UNITED STATES
DEPARTMENT OF THE INTERIOR
BUREAU OF LAND MANAGEMENTFORM APPROVED
OMB NO. 1004-0137
Expires: January 31, 2018**SUNDRY NOTICES AND REPORTS ON WELLS**
*Do not use this form for proposals to drill or to re-
abandoned well. Use form 3160-3 (APD) for such proposals.*5. Lease Serial No.
NMNM134867

☒ Oil Well ☐ Gas Well ☐ Other2. Name of Operator
MEWBOURNE OIL COMPANYContact: JACKIE LATHAN
E-Mail: jlathan@mewbourne.com8. Well Name and No.
HOSS 2/11 W2BO FEDERAL COM 211H9. API Well No.
30-015-441533a. Address
PO BOX 5270
HOBBS, NM 882413b. Phone No. (include area code)
Ph: 575-393-590510. Field and Pool or Exploratory Area
98220
Purple Sage Wellcamp (g)

Mewbourne Oil Company has an approved APD for the above well. Mewbourne requests approval of the following variance:

**PECOS DISTRICT
DRILLING OPERATIONS
CONDITIONS OF APPROVAL**

13-5/8" MN-DS Wellhead System

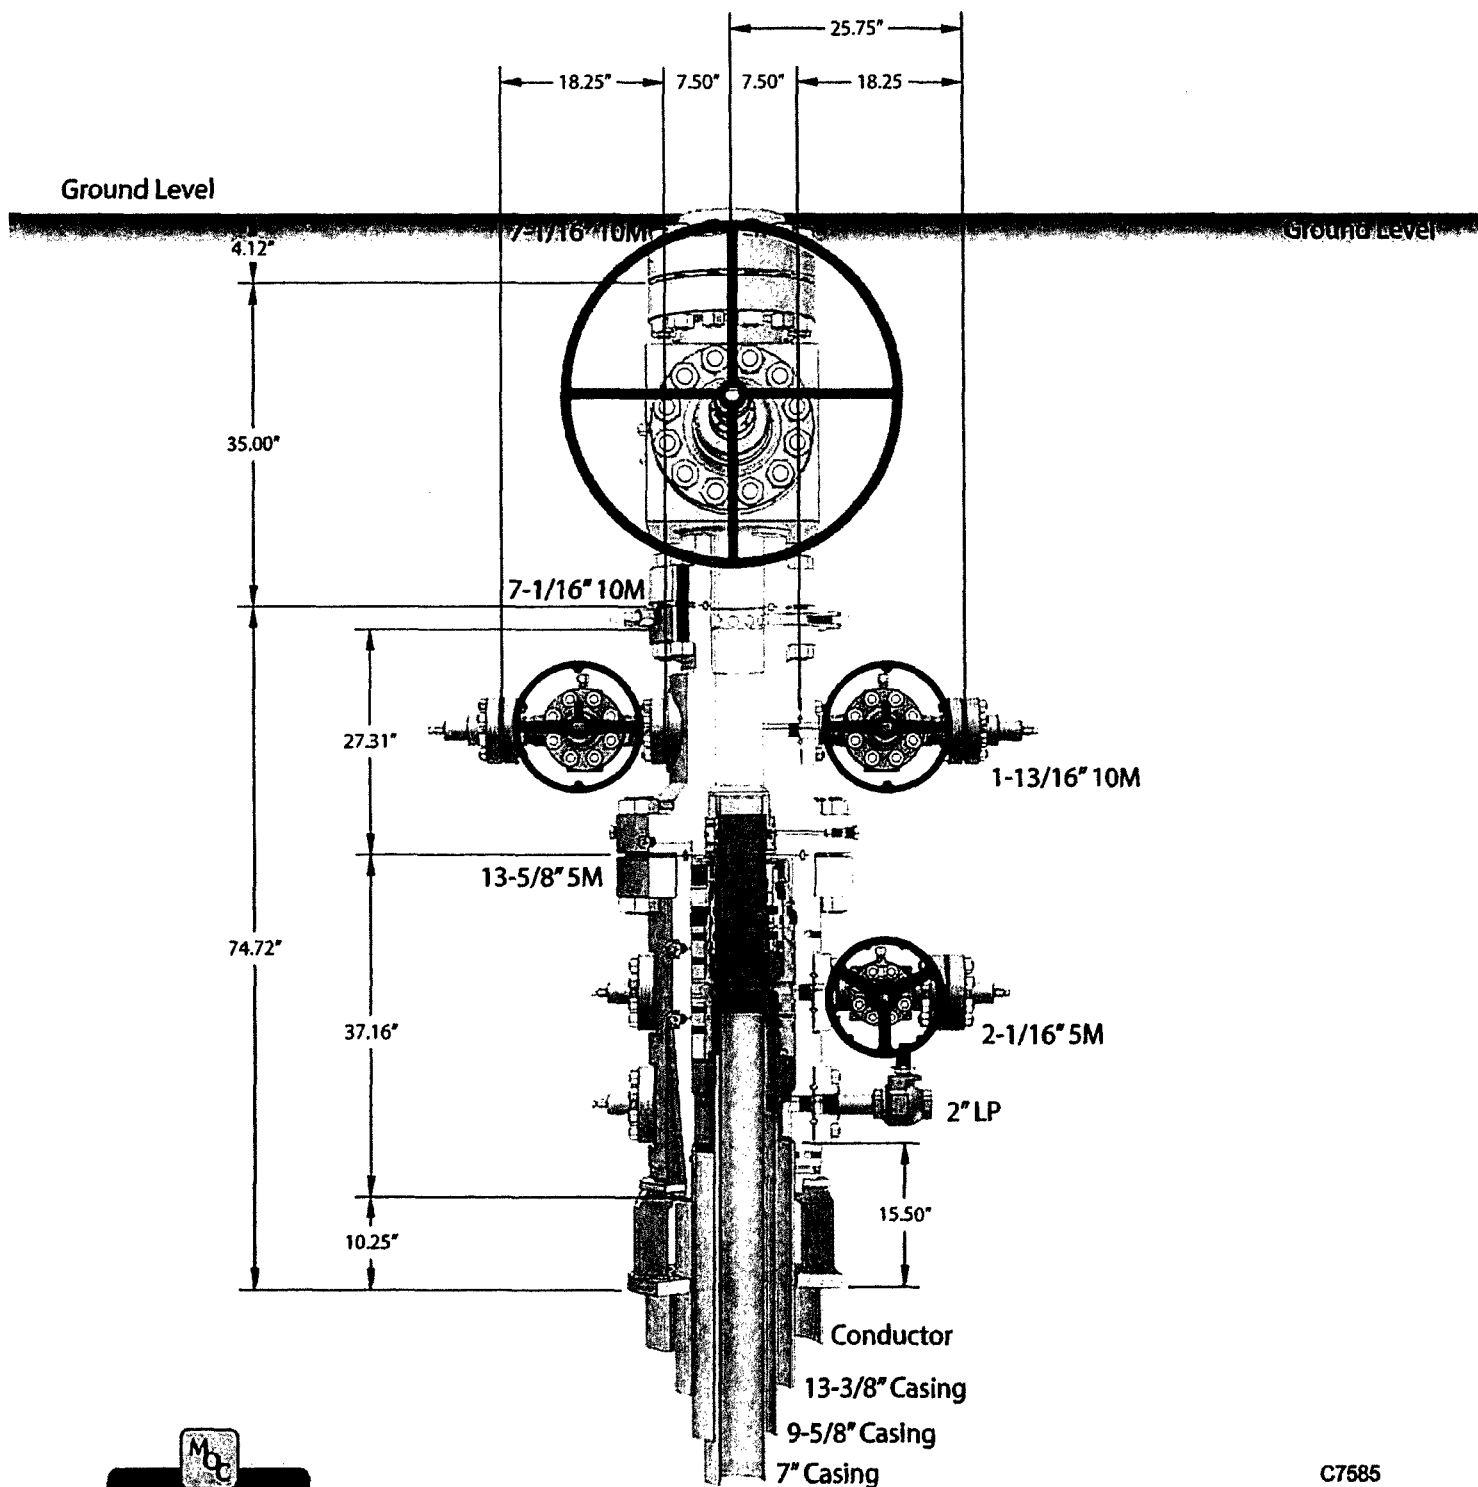
Use of a multi-bowl wellhead. See attached schematic.

4. **Operator has proposed a multi-bowl wellhead assembly. This assembly will only be tested when installed on the surface casing. Minimum working pressure of the blowout preventer (BOP) and related equipment (BOPE) required for drilling below the surface casing shoe shall be 5000 (5M) psi.**

- a. **Wellhead shall be installed by manufacturer's representatives, submit documentation with subsequent sundry.**
 - b. **If the welding is performed by a third party, the manufacturer's representative shall monitor the temperature to verify that it does not exceed the maximum temperature of the seal.**

- c. **Manufacturer representative shall install the test plug for the initial BOP test.**
 - d. **Operator shall perform the intermediate casing integrity test to 70% of the casing burst. This will test the multi-bowl seals.**

- e. **If the cement does not circulate and one inch operations would have been possible with a standard wellhead, the well head shall be cut off, cementing operations performed and another wellhead installed.**
